PD Modification Application: MM 25-1375

Hillsborough County Florida
Development Services Department

AGENCY REVIEW COMMENT SHEET

2.5 Proposed Site Plan (partial provided below for size and orientation purposes. See Section 8.2 for full site plan)

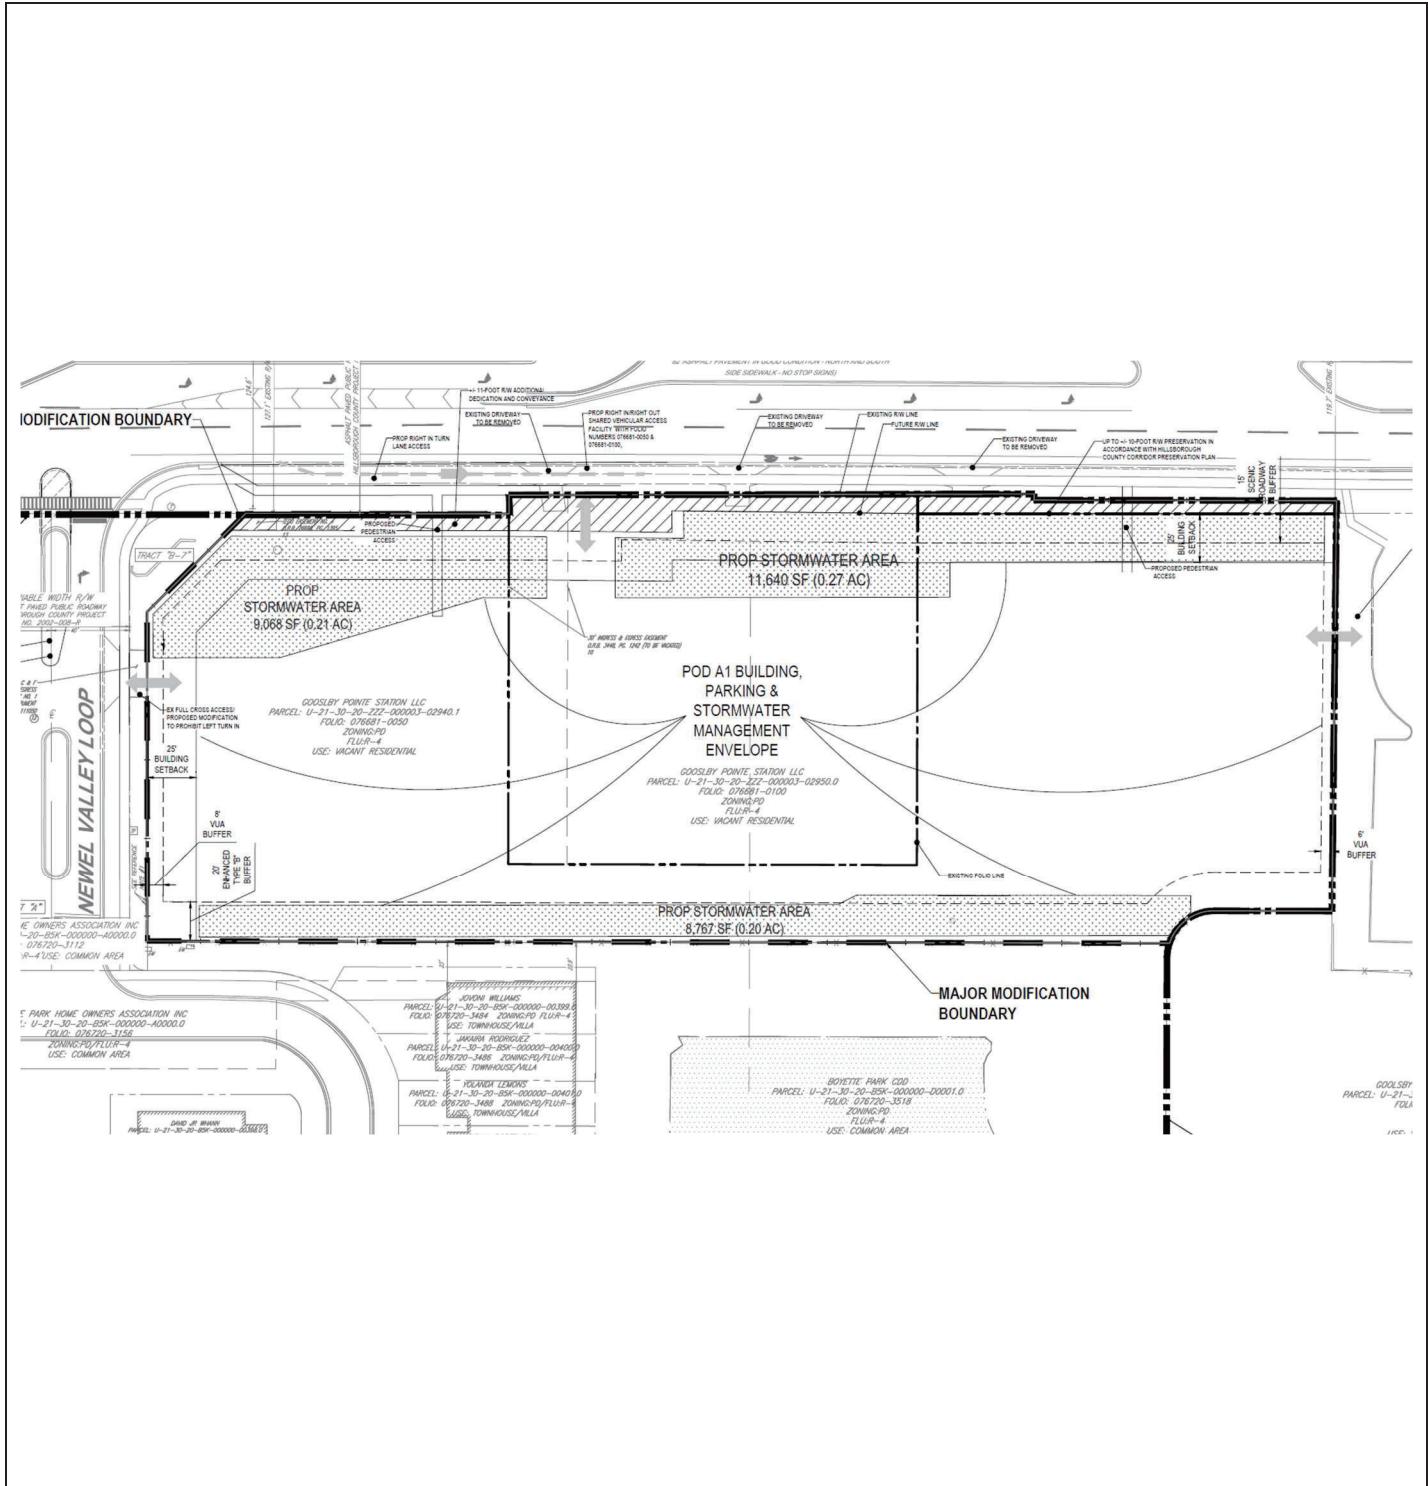
- Modify Sheet 2 of 2 (i.e. the remaining sheet) to restore the access to the previously approved (and code compliant) location, and restore label stating “+/- 11-foot R/W Additional Dedication and Conveyance” to instead use the existing approved language “+/- 11-foot R/W Additional Dedication and Conveyance – See Conditions of Approval”;

- On Sheet 2 of 2, change the label reading “Proposed Vehicular Cross Access with Folio 076720-1304 (May Be Adjusted)” to instead state “Proposed Vehicular and Pedestrian Cross Access with Folio 076720-1304 – See Conditions of Approval”.

- On Sheet 2 of 2, restore the “no left turn arrow” symbology to the site as is shown below and that is shown on the existing approved plan (which staff notes clarifies which left turn is being restricted).

2.5 Proposed Site Plan (partial provided below for size and orientation purposes. See Section 8.2 for full site plan)

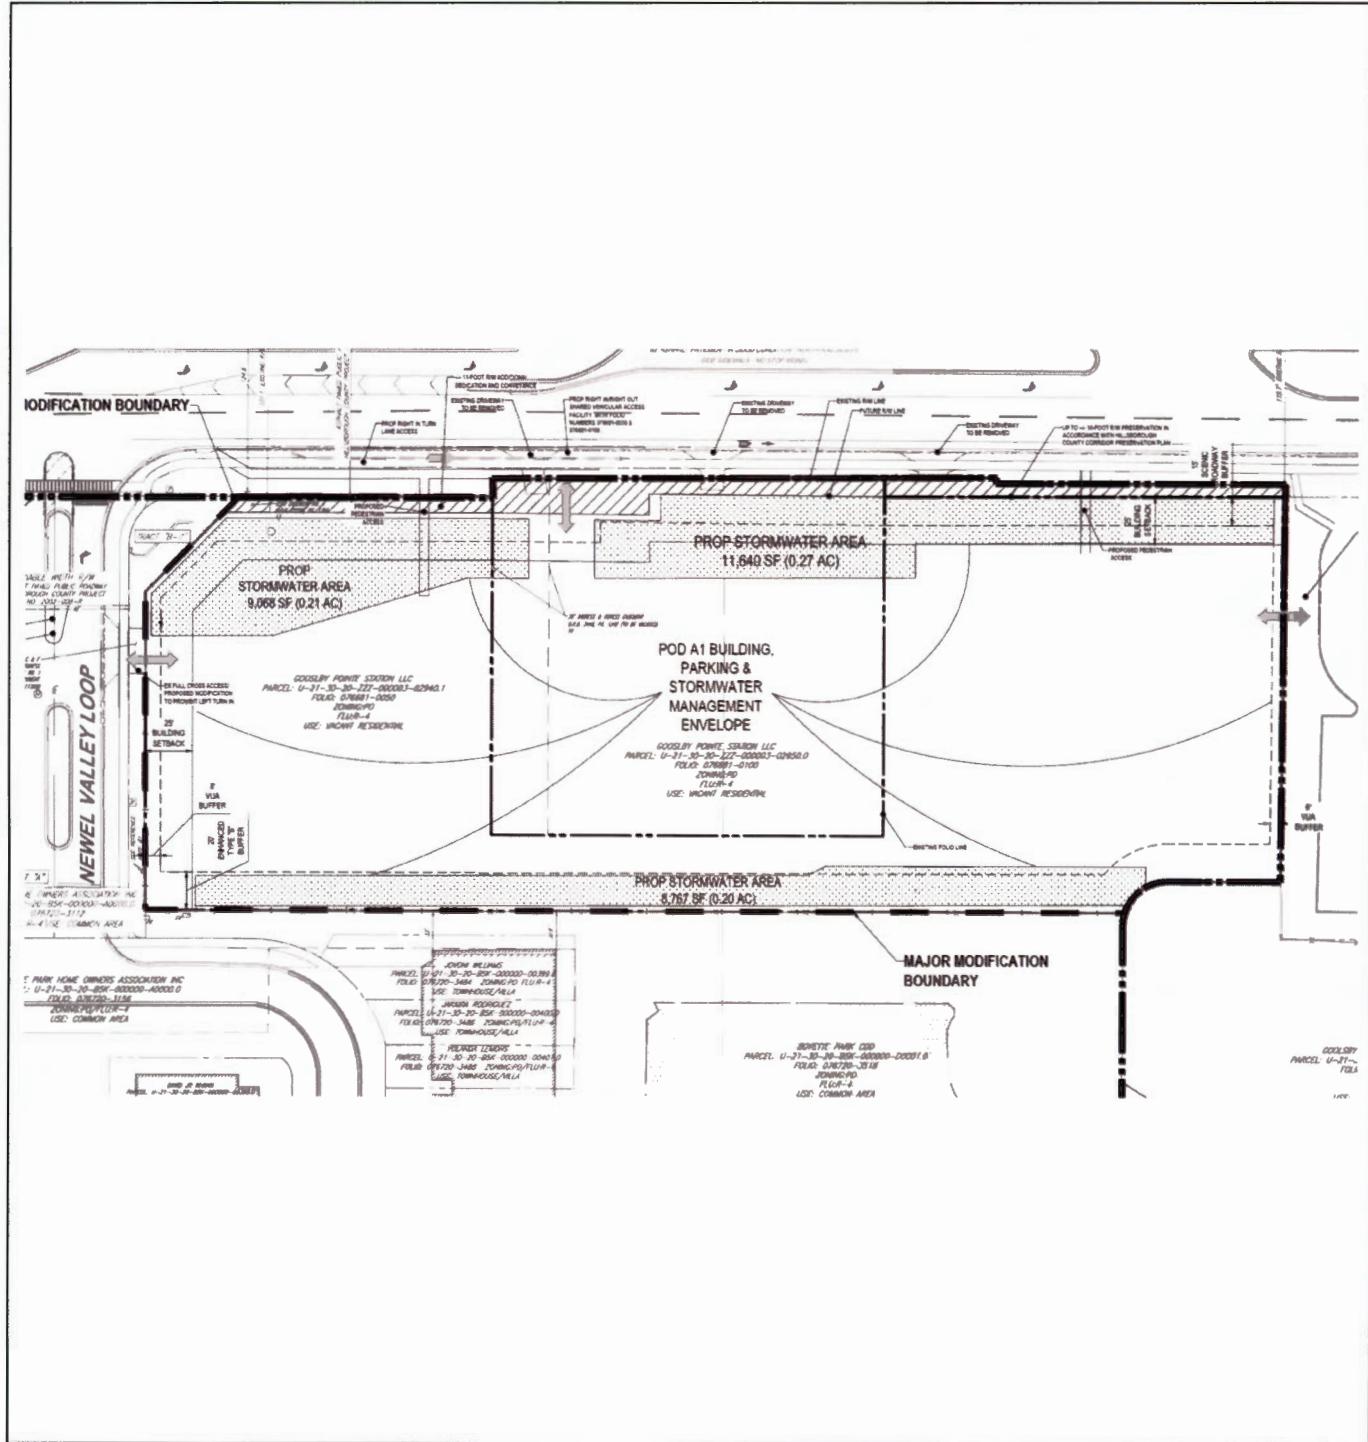
4. Modify Sheet 2 of 2 (i.e. the remaining sheet) to restore the access to the previously approved (and code compliant) location, and restore label stating “+/- 11-foot R/W Additional Dedication and Conveyance” to instead use the existing approved language “+/- 11-foot R/W Additional Dedication and Conveyance – See Conditions of Approval”;

5. On Sheet 2 of 2, change the label reading “Proposed Vehicular Cross Access with Folio 076720-1304 (May Be Adjusted)” to instead state “Proposed Vehicular and Pedestrian Cross Access with Folio 076720-1304 – See Conditions of Approval”.

6. On Sheet 2 of 2, restore the “no left turn arrow” symbology to the site as is shown below and that is shown on the existing approved plan (which staff notes clarifies which left turn is being restricted).
